Revise Sheets as Required:
A101

OCO MEALS ON WHEELS

SCENIC AVE
Mexico, New York

ADD-2A

Revised Partial Plan

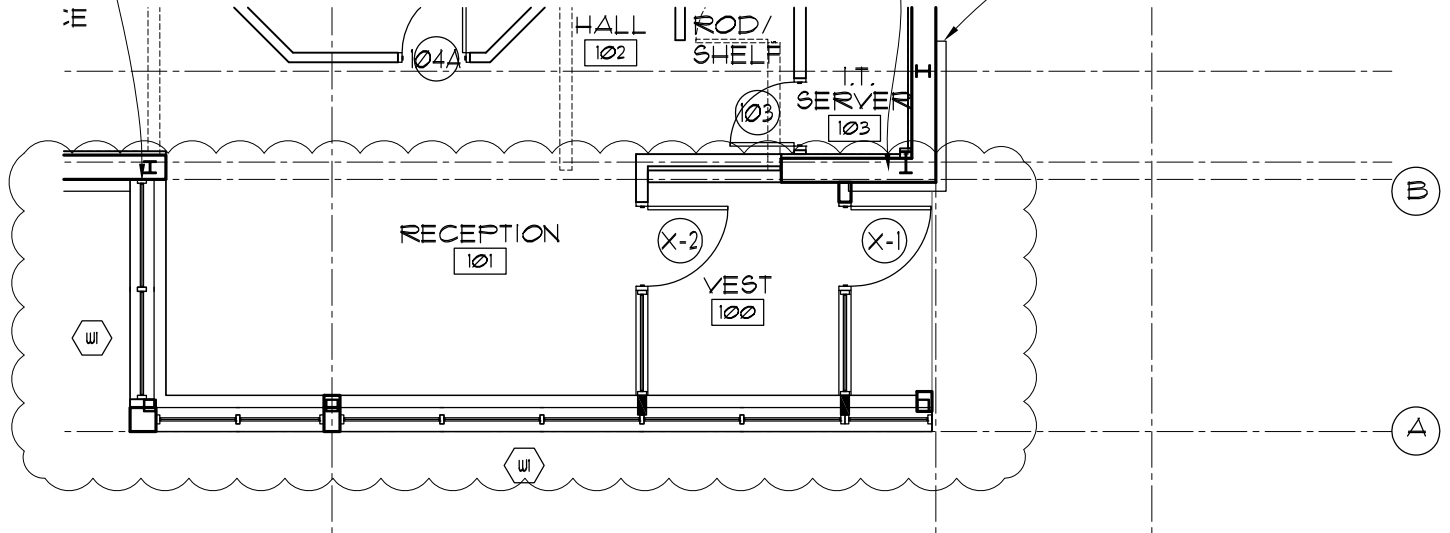
1. NEW TERMINATION CLOSURE PIECE AT NEW SLOPED SILL / CAP FLASHING AND EXISTING SILL FLASHING TO REMAIN.

2. NEW ALUMINUM CAP/SILL FLASHING AND END WALL FLASHING W/ SEALANT / BACKER ROD AT ENTRY WALL AREA.

3. NEW STUD WALL FULL HEIGHT FOR BRACING EXISTING LOW BRICK WALL. PROVIDE MASONRY GALV. ANCHORS AS REQUIRED. NEW GWB FINISH AT BOTH SIDES. REMOVE METAL SIDING AS REQUIRED. INSULATE WALLS W/ R-21 BATT INSULATION AND 6 MIL POLY V.B.

WINDOW SILL SHOWN. (LAYER PREVIOUSLY TURNED OFF)
